THE SHOP'S AT MERIDIAN RANCH

FILING NO. 1A, LOT 2
 SITE DEVELOPMENT PLAN
 EL PASO COUNTY, COLORADO
 FALCON, COLORADO

Shop's @ Meridian Ranch
 Site Development Plan
 Meridian Ranch
 Falcon, CO

FILE NUMBER: PPR18033

OWNER INFO
company name HUNJIAN GAS STATIONS LLC
address 12599 MT. LINDSEY DR.
city/state PEYTON, CO 80831
phone no
Update file number
DRAWING NO. 1
SITE DEVELOPMENT PLAN

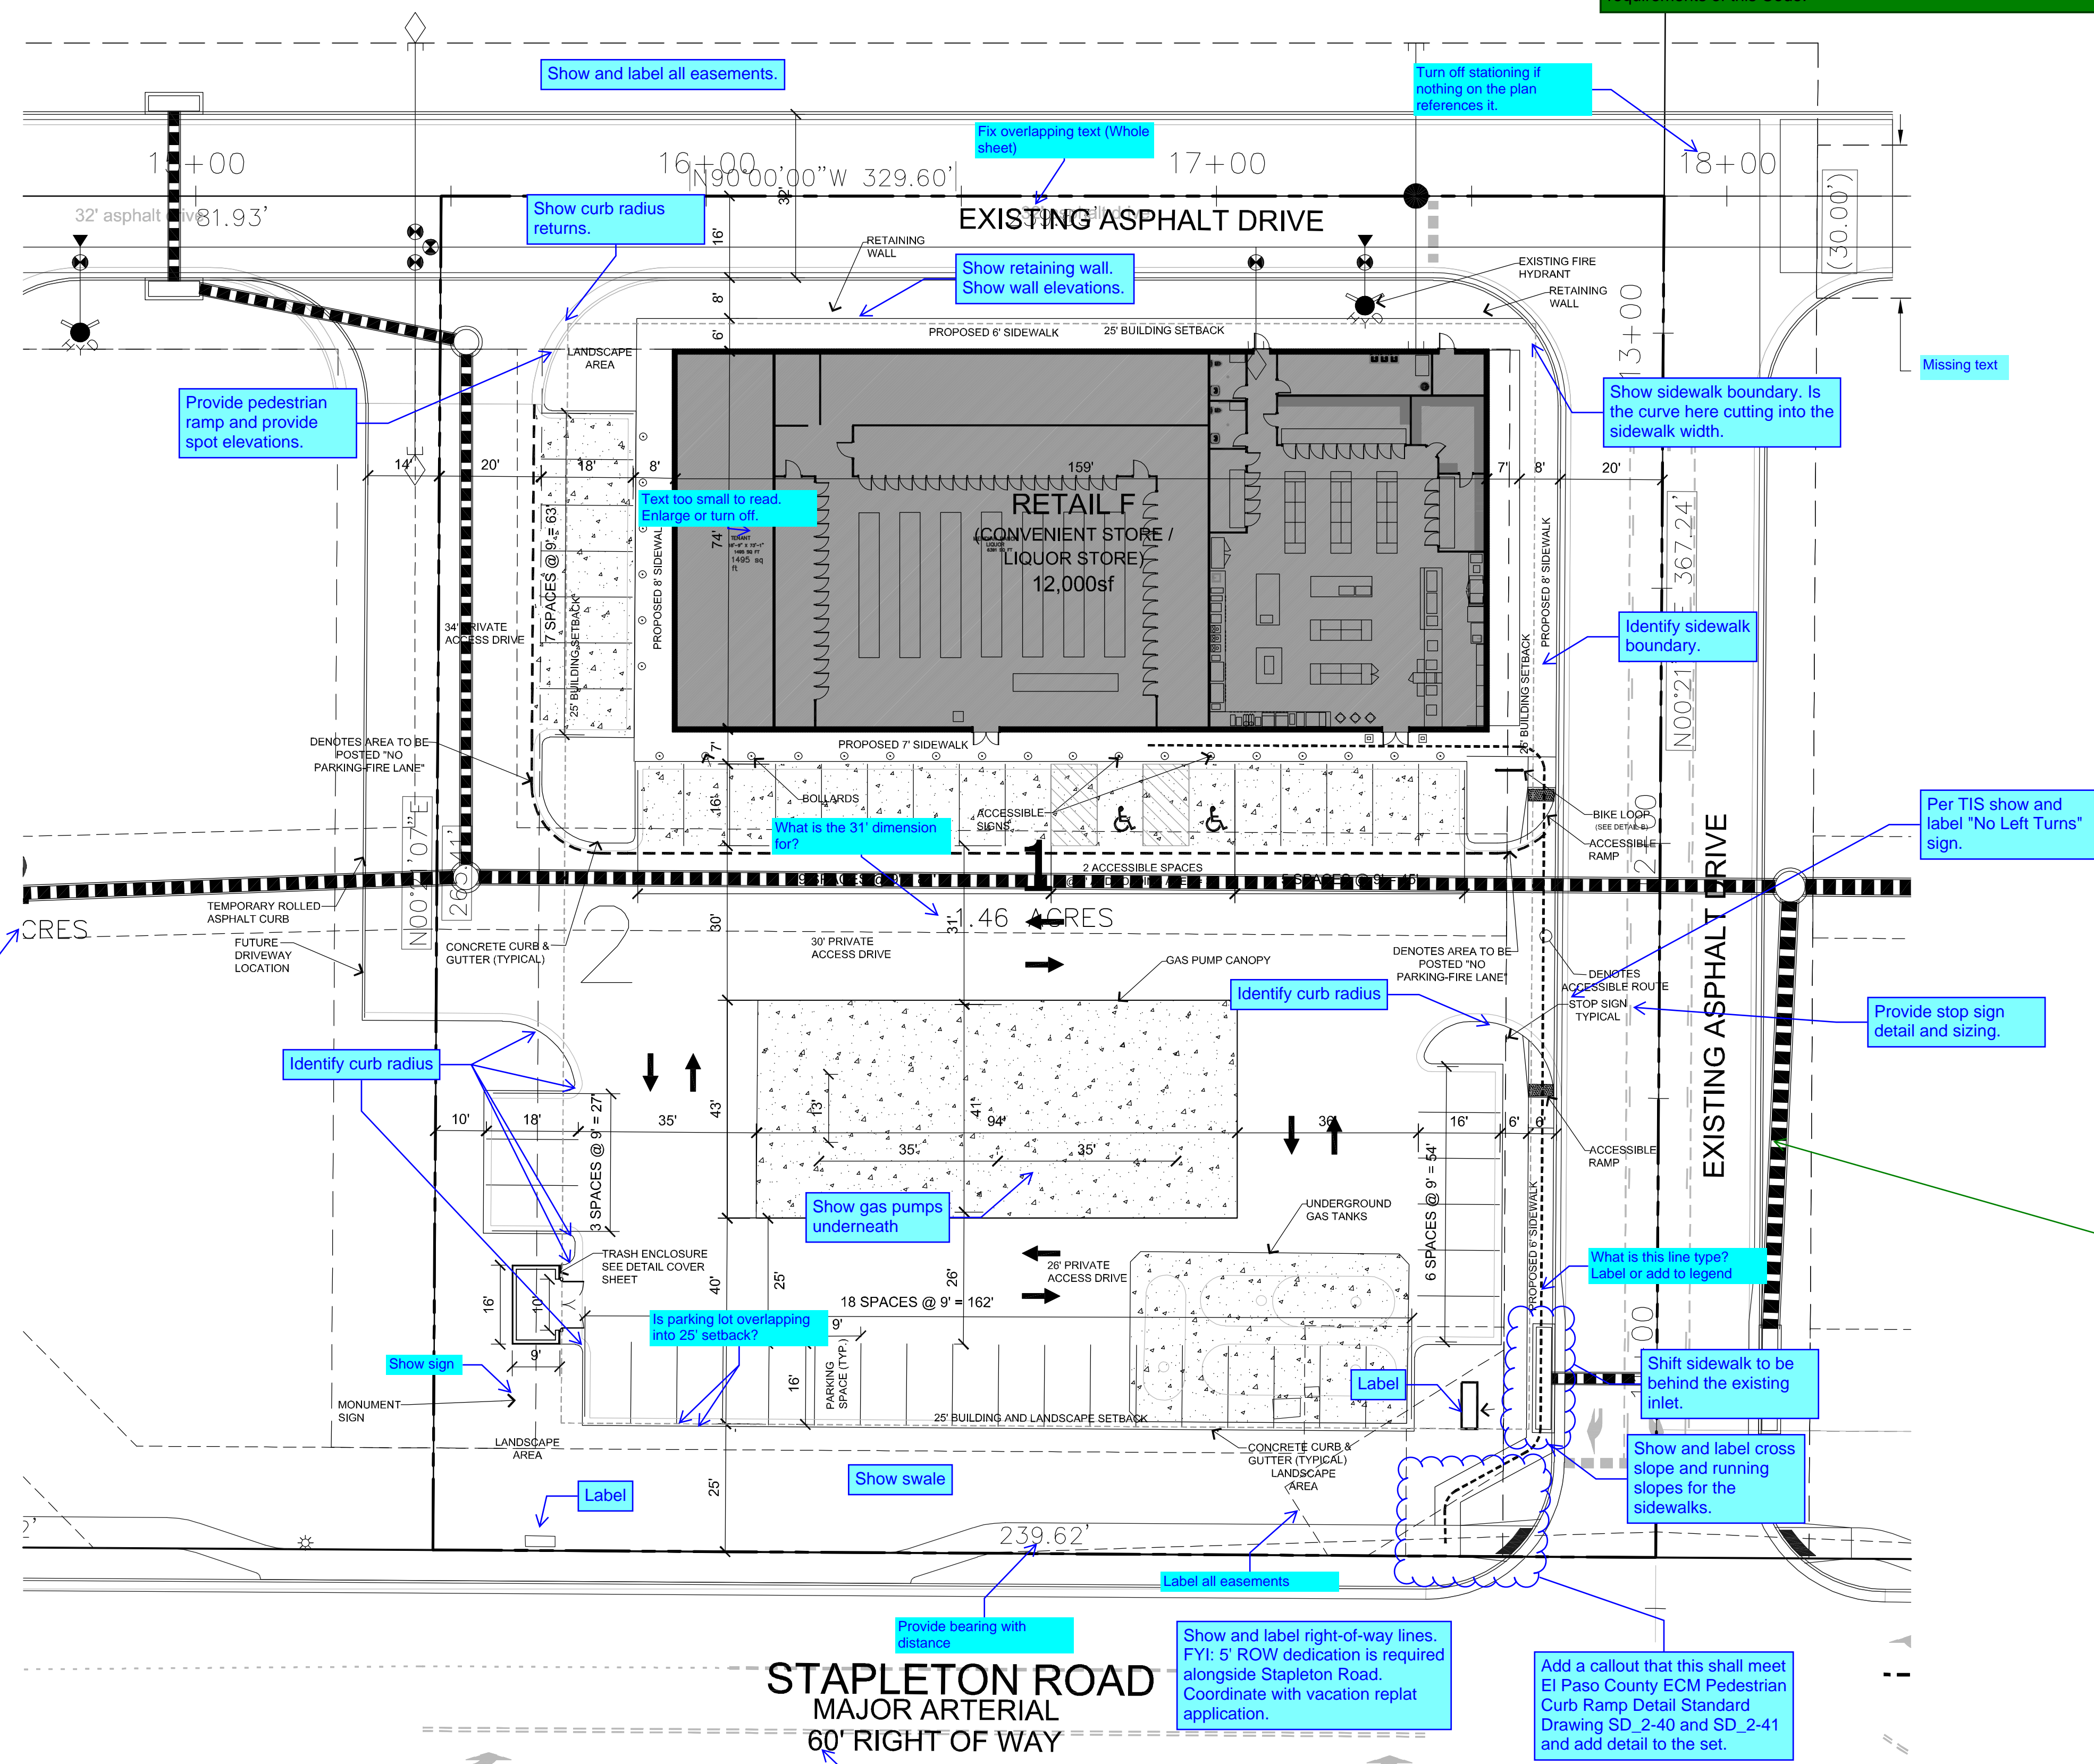
You need to identify and Provide an area for truck loading and turnaround in accordance with LDC requirements

Truck Loading and Turnaround Areas.
 (1) Truck Loading and Turnaround Areas Required. Loading and turnaround areas shall be provided for all non-residential buildings of 3,000 square feet or greater. Maneuvering or access areas may be located on adjacent lots or parcels as long as a recorded document is provided for common use and maintenance. 1 Space is required/ 14 feet by 18 feet is the dimensions of the loading space/ 14 feet vertical Clearance/ 24 feet Maneuvering Aisle Width

(2) Design to Minimize Noise Impacts. Truck loading and turnaround areas shall be designed and located to minimize any potential noise impacts to adjacent residential properties.

(3) No Obstruction of Parking Lot Aisles. Loading areas shall be designed so that a maneuvering or parked delivery vehicle will not obstruct parking lot aisles used by employees or customers.

(4) Onsite Turnaround Area Required. An onsite turnaround area shall be provided for all loading areas. Only turning radii found to be acceptable by the Institute of Traffic Engineers or determined to be acceptable by the ECM Administrator shall be acceptable for compliance with this requirement.

(5) Loading Areas Screened. Loading areas shall be screened from view from a public road or residential areas. Screening shall meet the screening requirements of this Code.

Coordinate with traffic engineer to show recommended signs and markings.

tax schedule no.	4230319052	Replace with the Correct Parcel No : 4230319056
area	3.43ac	
ex zone	n/a	
proposed zone	CR	
ex use	vacant	
proposed use	commercial center	Replace with the correct acreage/ on both Site development pages
master plan development schedule	Falcon/Peyton Small Area Plan FALL 2023	
area	1.46ac	
proposed use	commercial center	
bldg area	12,000sf	
max. bldg height	45'	
prop. bldg height	44'	
bldg setbacks		
front	25'	
side	25'	
rear	25'	
%lot coverage		
bldgs	19% (12,000sf)	
impervious	66% (42,472sf)	
landscaping	15% (9,300sf)	
use	retail F commercial center	
bldg area	12,000sf	
ratio	1/250sf	
required (incl h/c)	48 (incl 2hc)	
provided	50 (incl 2hc)

I'm not sure what this line is... but its covering up parking space information and obstructing the site development plans layout. Label transparent or remove please

The Maximum Number of Compact Parking Spaces Allowed. A maximum of 30% of the number of required parking spaces may be compact parking spaces.
 Parking space dimensional Requirements Minimum standards Standard Parking spaces
 Parking Angle 1 / Width of Space / Depth of Space / Aisle Width 2-Way / Aisle Width 1-Way / Depth of Interlocking Spaces / Overhang 3
 0 degrees / 9ft / 22 ft / 20ft / 12 ft / 18 ft / 0 ft
 Parking space dimensional Requirements for Compact Spaces
 0 degrees / 8ft / 20ft / 12ft / 16ft / 0ft
 You have exceeded the allowable amount of compact spaces if you need additional dimensional requirements, refer to LDC 6.2.5 Parking Loading and Maneuvering standards.
